DATE ~~R~~ Sep.15/01**V2500-A1 PROPULSION SYSTEMS SERVICE BULLETIN**

This document transmits Revision 2 to Service Bulletin EV2500-72-0051

**V2500-ENG-72-0051**  
 Transmittal - Page 1 of 2

ENGINE – LP COMPRESSOR – INCORPORATE A FUEL DRAIN TUBE IN THE FAN FRAME ASSEMBLY

Rework of the Fan Frame Assembly - Renumber the Part Number  
Figure 6

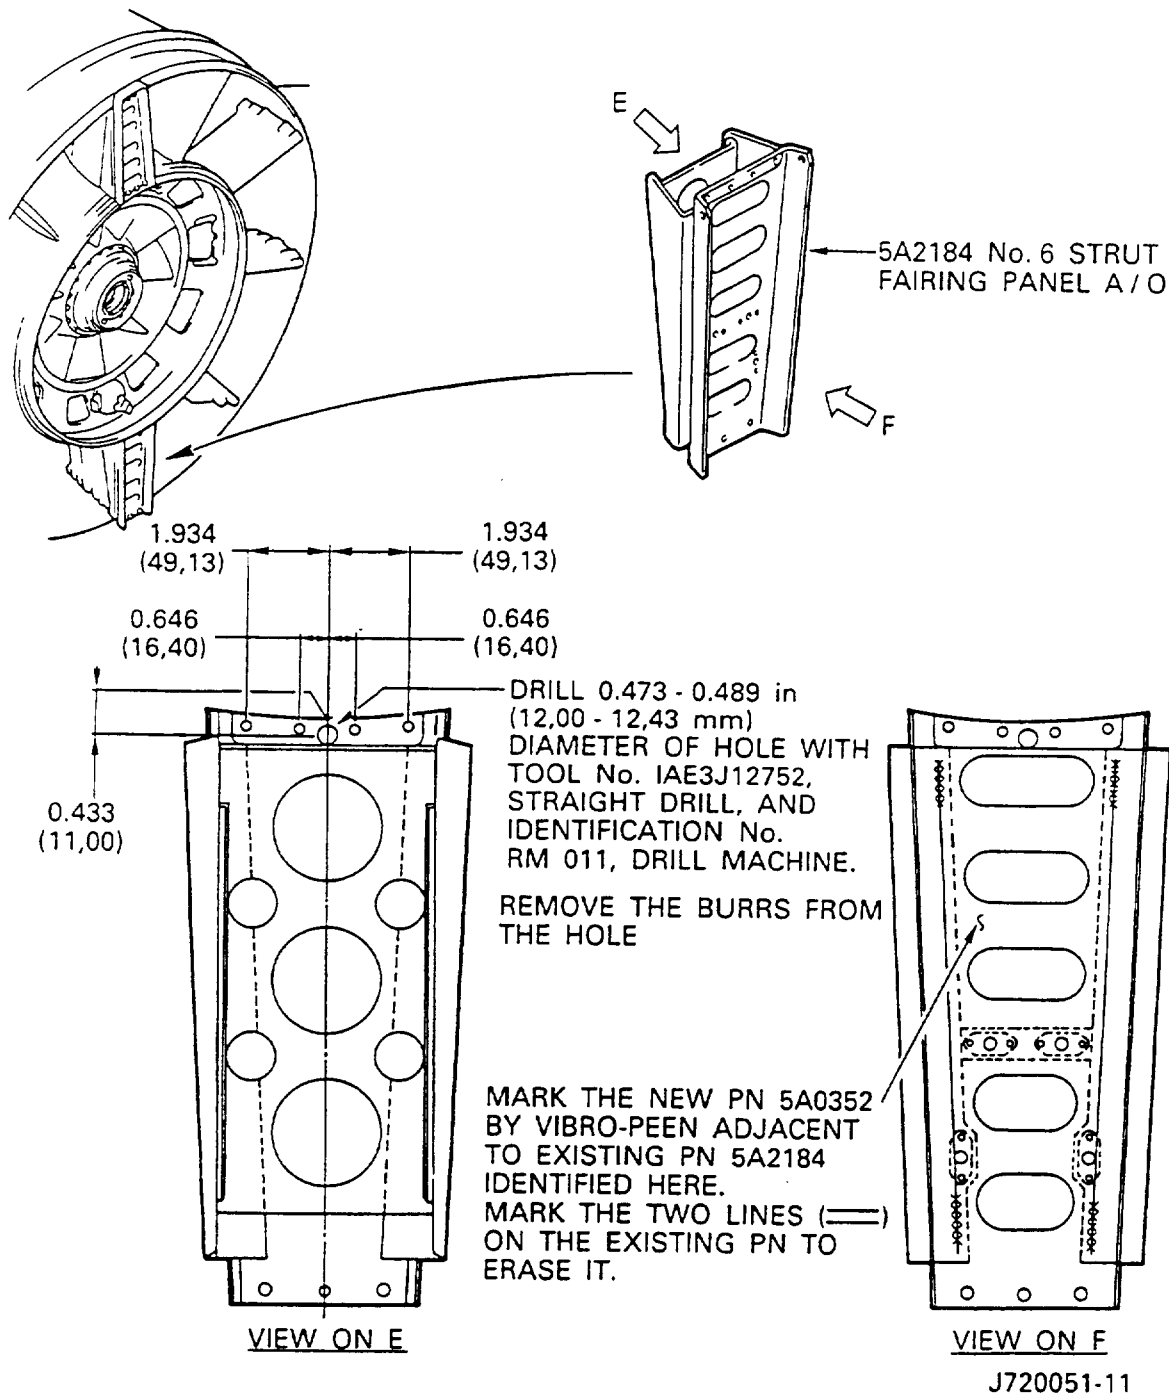
(8) Renumber the Part Number of the Fan  
Frame Assembly with the Vibro-Peen

Existing	Re-number
5A0365	5A0407
5A0362	5A0401
5A0364	5A0405
5A0363	5A0403
5A0366	5A0409

NOTE: New Part Number must be marked on the right area of the erased  
Pre-Service Bulletin No. V2500-ENG-72-0009 Part Number in the Fan  
Frame marking area.

Rework of the No.6 Strut Fairing Panel  
Figure 7

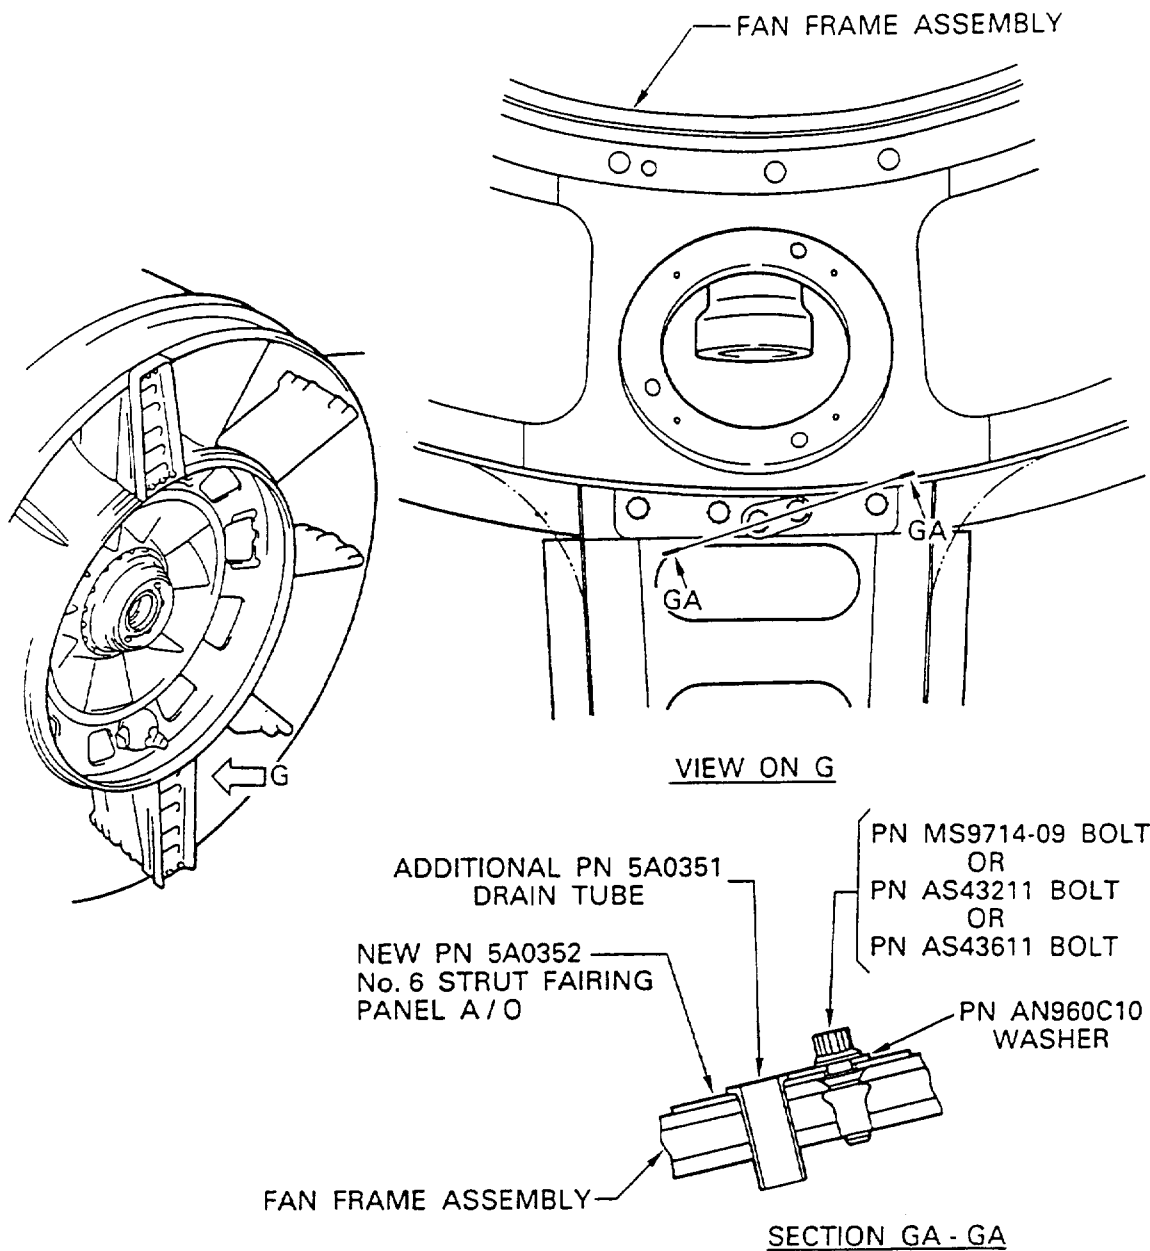
(11) Drill the hole on the No. 6 Strut  
Fairing Panel A/0 as follows:

(c) Drill 0.480in. (12,20 mm)  
diameter of hole on the No. 6  
Strut Fairing Panel A/O.

- (12) Renumber the Part Number of the No. 6 Strut Fairing Panel A/O with the Vibro-Peen Refer to Figure 7, and 1.K.(4)

Assembly of the No.6 Strut Fairing Panel and the Drain Tube  
Figure 8 (Sheet 1 of 2)

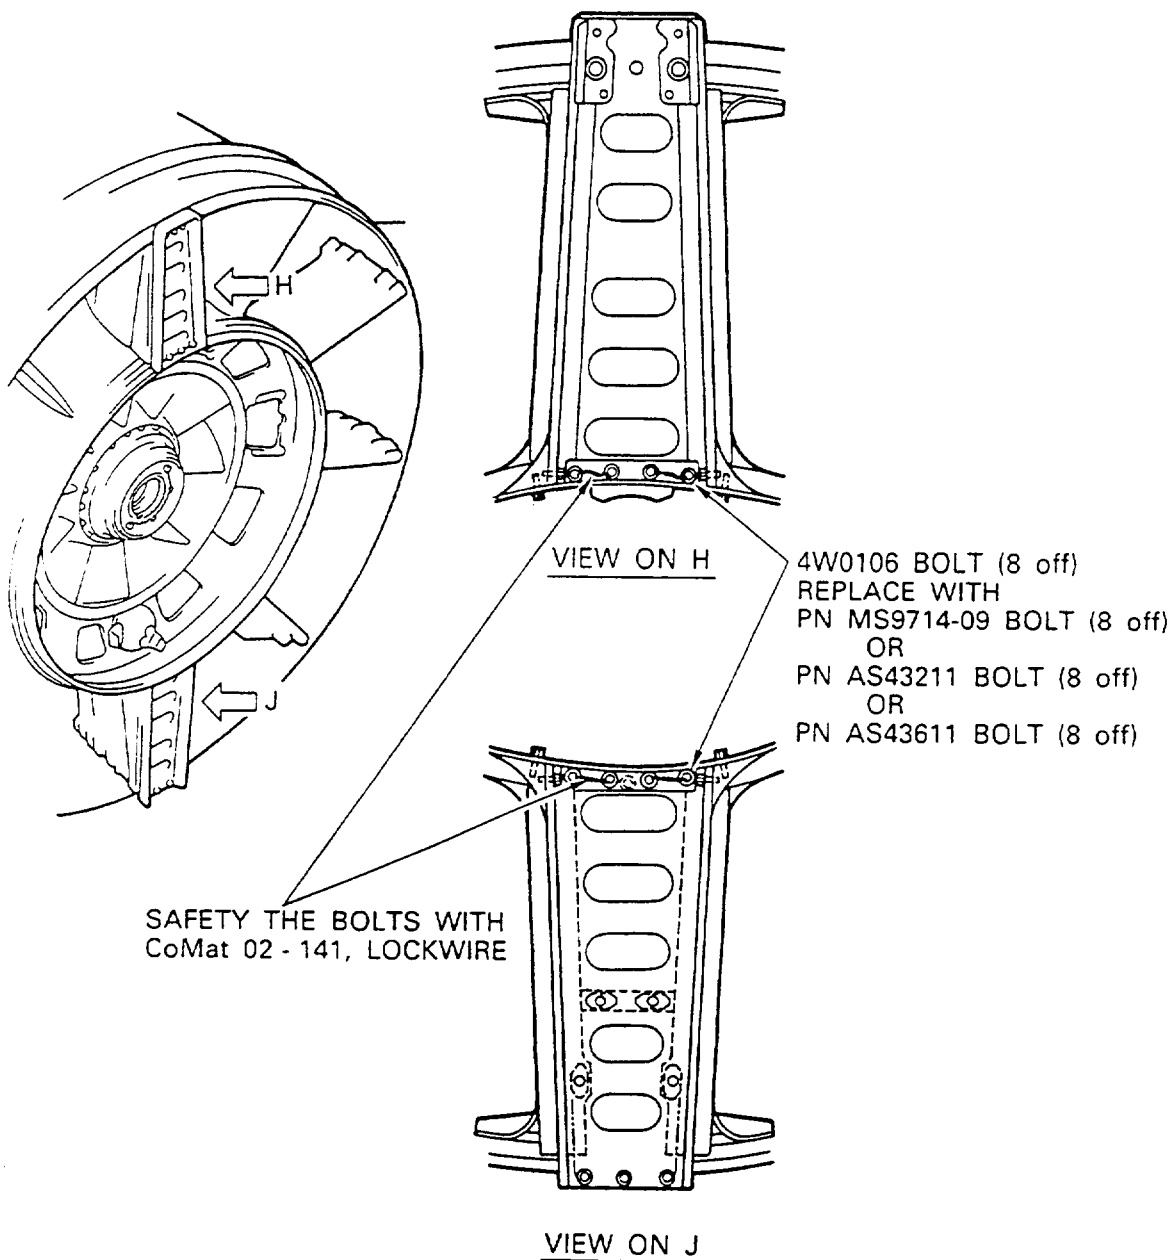
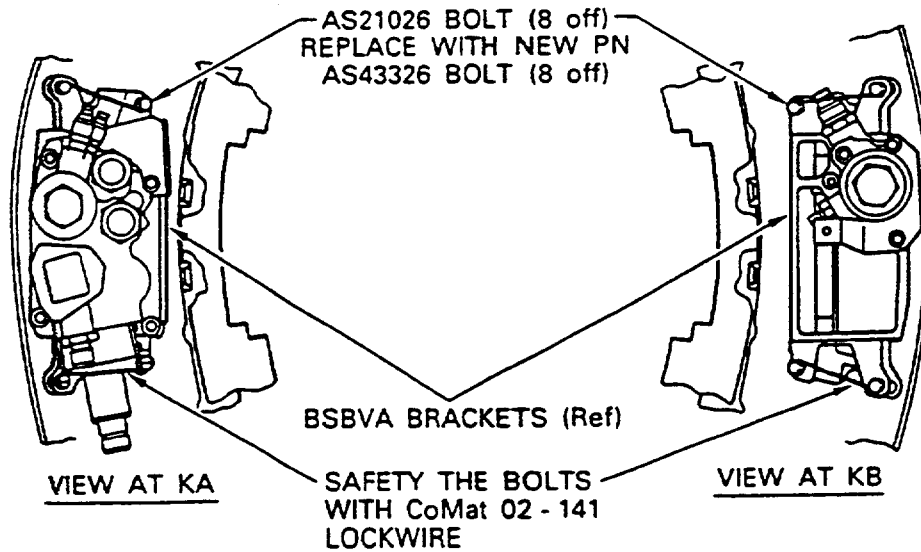
- (ii) The existing eight 4W0106, Bolts, which attach the No. 1 and No. 6 Struts Fairing Panel A/O's are replaced with eight new MS9714-09, Bolts, or AS43211, Bolts, or AS43611, Bolts, or AS44011, Bolts. (See Fig. 8).
- (iii) The existing eight AS21026, Bolts, which attach the BSBVA Brackets are replaced with eight new AS43326, Bolts. (See Fig. 9).
- (iv) The bolts changed by this Service Bulletin must be safetied with the lockwire.

- (3) Install new 5A0351, Drain Tube, to the Fan Frame Assembly through the hole in reworked 5A0352, No. 6 Strut Fairing Panel, with AN960C10, Washer, and new MS9714-09, Bolt, or AS43211, Bolt, or AS43611, Bolt, or AS44011, Bolt. Torque the Bolt to 36 - 45 lbfin (4,00 - 5,00 Nm). (Refer to figure 8, and 1.K.(4).)

**NOTE:** Do not install the right side bolt and washer adjacent to the drain tube hole on the No. 6 Strut Fairing Panel this time.

- (4) Safety eight new MS9714-09, Bolts, or AS43211, Bolts, or AS43611, Bolts, or AS44011, Bolts, which attach the No. 1 and No. 6 Struts Fairing Panel A/O's to the Fan Frame Assembly with CoMat 02-141, Lockwire. (Refer to Figure 8.)

Assembly of the BSBVA Brackets  
Figure 9

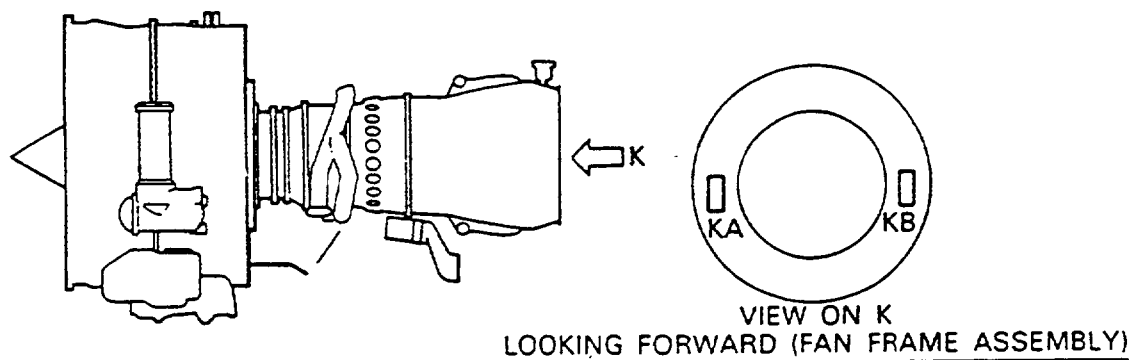
- (5) Replace eight AS21026, Bolts, which attach the BSBVA Brackets with eight new AS43326, Bolts. Install the BSBVA Brackets by the approved procedures in the Engine Manual, 72-00-40, Installation-09, Config-1. (Refer to Figure 9, and 1.K.(3).)

- (6) Safety eight new AS43326, Bolts, which attach the BSBVA Brackets, with CoMat 02-141, Lockwire. (Refer to Figure 9.)
